U.S. NUCLEAR REGULATORY COMMISSION

Report Nos. 50-456/94008(DRP); 50-457/94008(DRP)

Facility Name: Braidwood Station, Units 1 and 2

Areas Inspected: Special, reactive safety inspection to review the circumstances surrounding the inoperability of both trains of Control Room Ventilation.

FIGURE 1 CONTROL ROOM HVAC SUPPLY TRAIN A

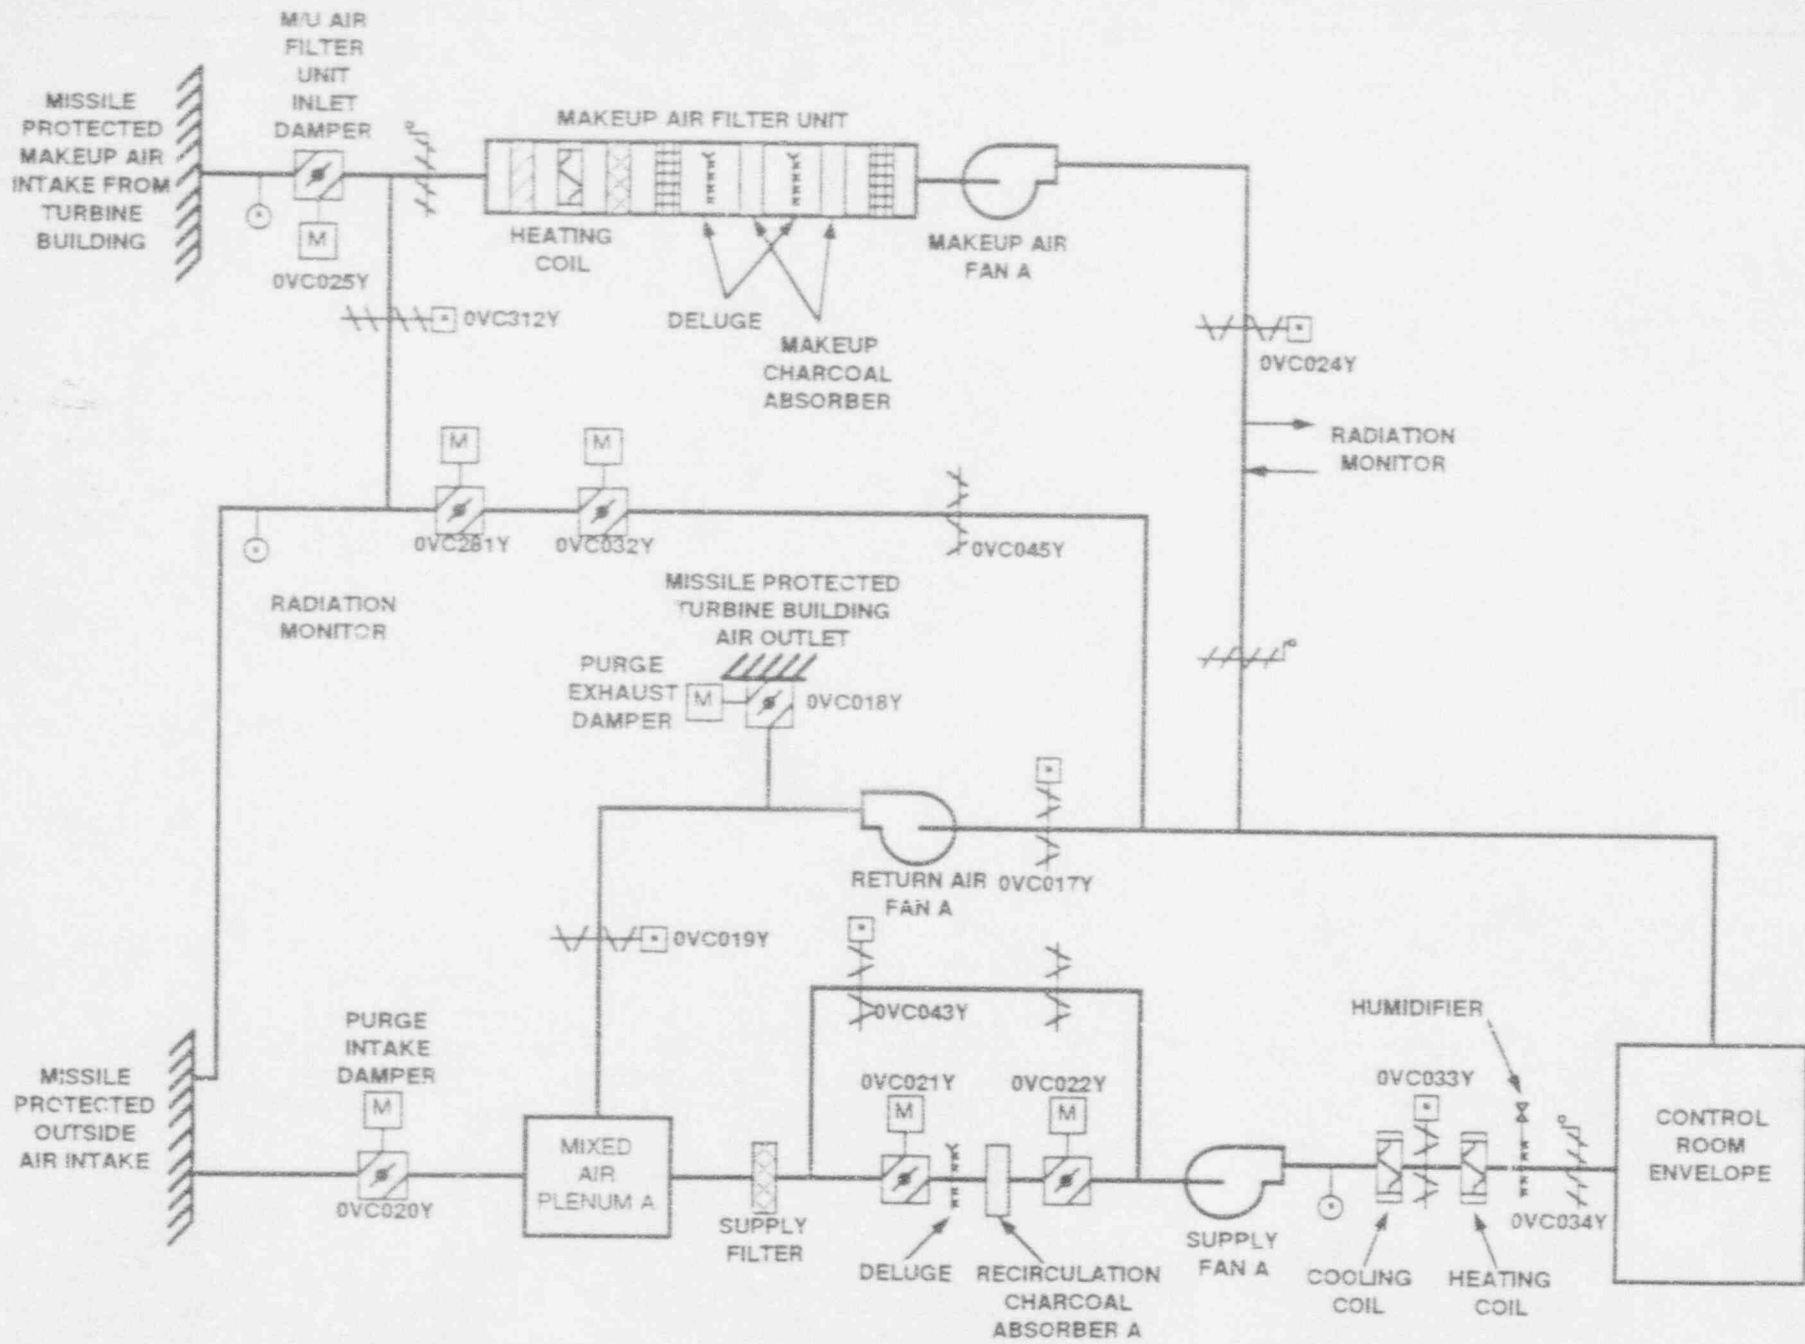
If high radiation is detected in the outside air during normal operation, the Makeup Air Fan automatically starts, the inlet and discharge dampers (OVC025Y for Train A; OVC009Y and OVC008Y for Train B) automatically open to provide makeup air to the return fan suction to mix with the return air. The remainder of the system flowpath is identical to the normal flowpath with the exceptions that the supply air to the Control Room Envelope automatically passes through the charcoal adsorber.

Purging of the Control Room Envelope would occur after a fire to remove the smoke. During purging operations of the Control room Envelope, air is taken in through a normally closed purge intake line (OVC020Y for Train A; OVC004Y for Train B) off of the missile protected outside air intake. The air passes through the mixed air plenum and is delivered to the Control Room Envelope in a normal manner. However, the exhausted air from the Control Room Envelope (return air) is discharged to the turbine building through the normally closed purge outlet damper (OVC018Y for Train A; OVC002Y for Train B).

Damper OVC018Y (Attachment 1) failed to open. EMD found motor grounded and dead battery pack. Both the motor and battery pack, as well as other failed components were replaced and operationally checked by cycling the damper and the damper was returned to service.

FIGURE 2 CONTROL ROOM HVAC SUPPLY TRAIN B

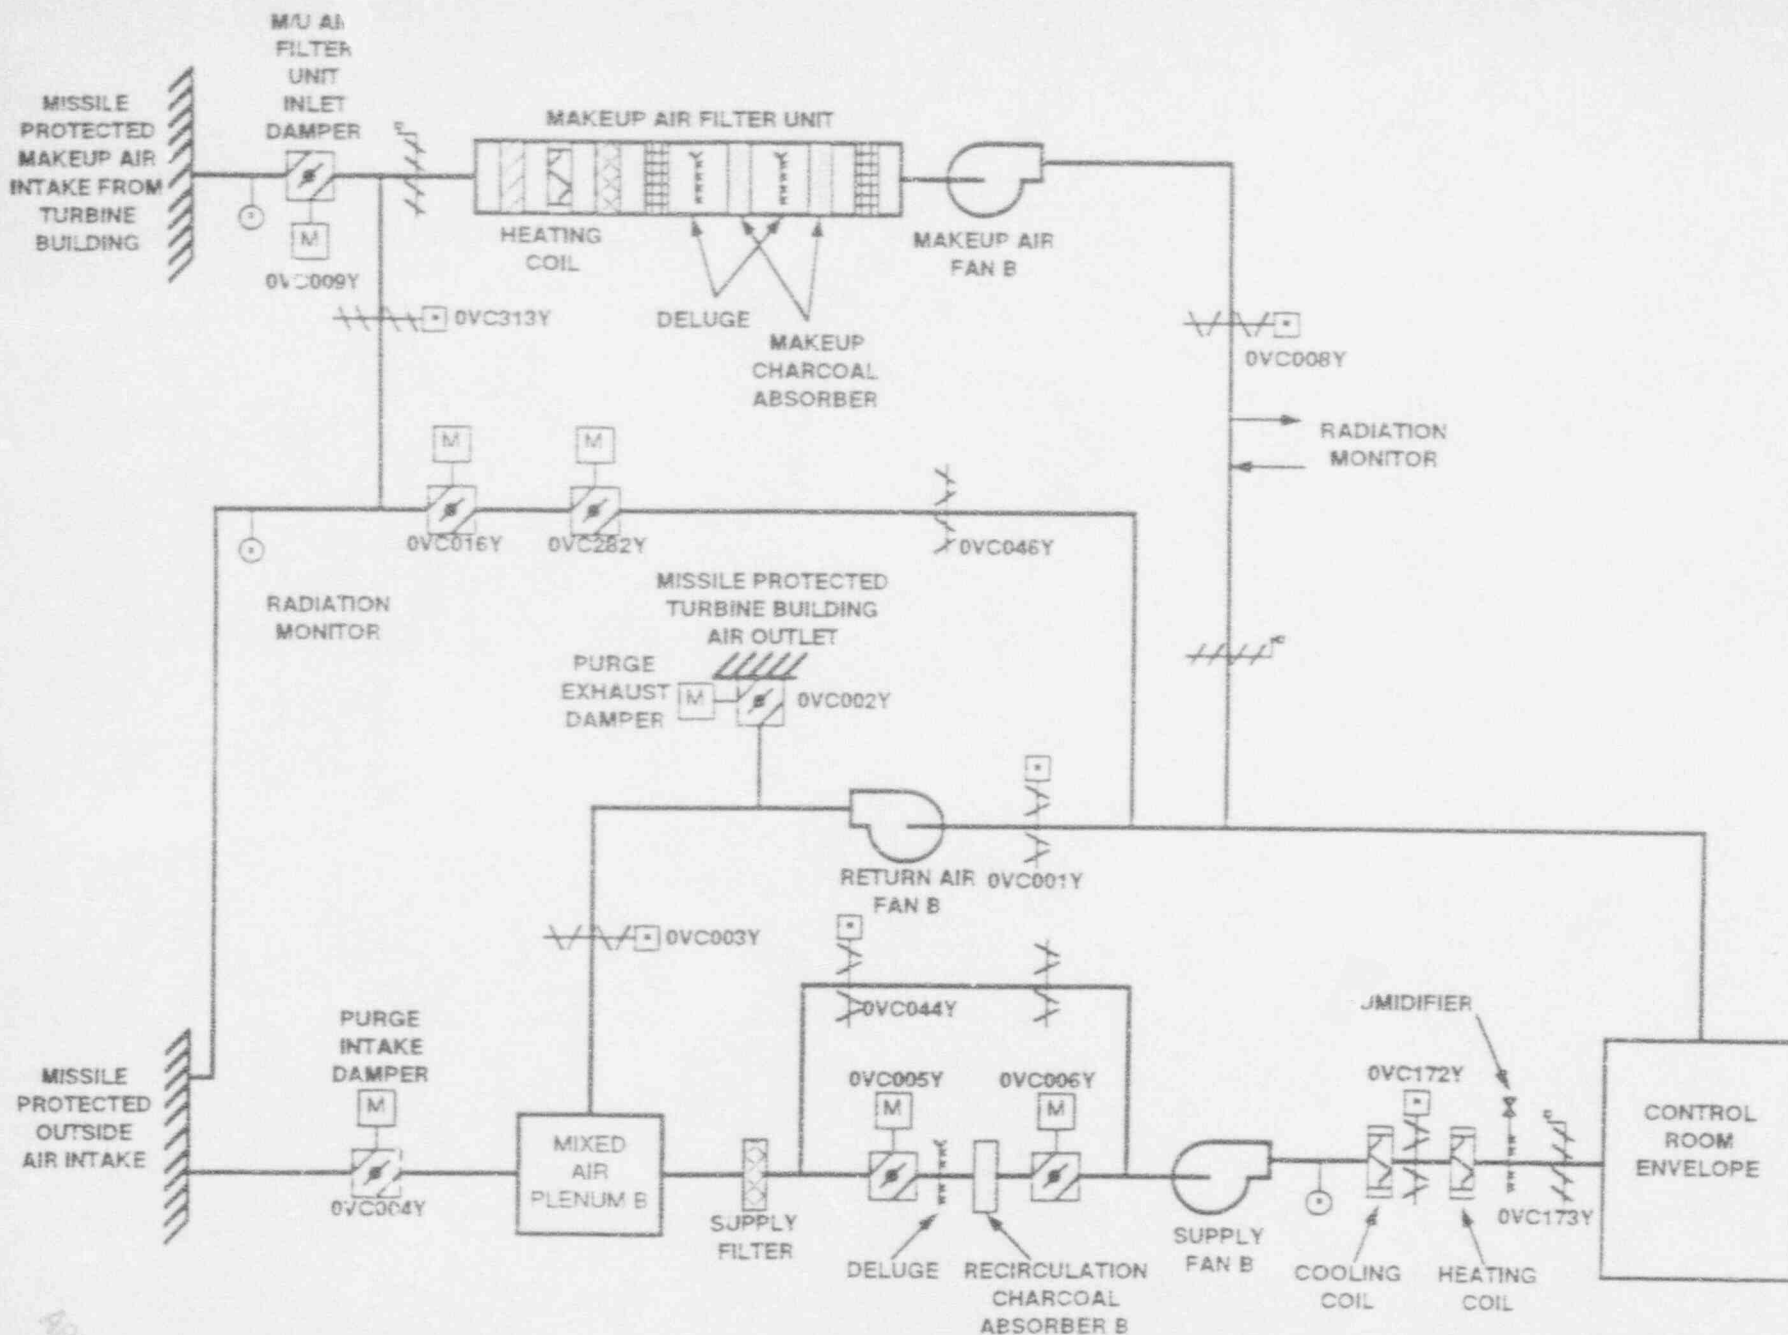
Damper OVC313Y (Attachment 2) did not close on loss of normal power supply during initial installation testing. The Operational Analysis Department (OAD) replaced the battery associated with damper OVC313Y and completed a satisfactory retest prior to turning the system over to System Engineering for pre-operational testing.

Damper OVC04Y (Attachment 2) would not open. EMD found motor grounded and dead battery pack. Both the motor and battery pack, as well as other failed components, were replaced and operationally checked by cycling the damper and the damper was returned to service.

Damper OVC16Y (Attachment 2) did not open when the VC supply fan was started. EMD found the motor grounded and the backup battery bad. Both the motor and battery pack, as well as other failed components, were replaced and the damper was returned to service.

Damper OVC02Y (Attachment 2) did not actuate when a purge signal was manually generated. EMD replaced both actuators (which included the motor and battery pack) and observed the damper stroke with proper indication prior to returning the damper to service.

Preoperational testing of the VC system verified the support functions of the backup batteries. Additionally, during testing, a failure of the battery for damper OVC313Y (Attachment 2) occurred on January 6, 1987. Documentation verified that the battery was replaced and returned to operable. The vendor manual contained information for installing the batteries. These instructions were followed.
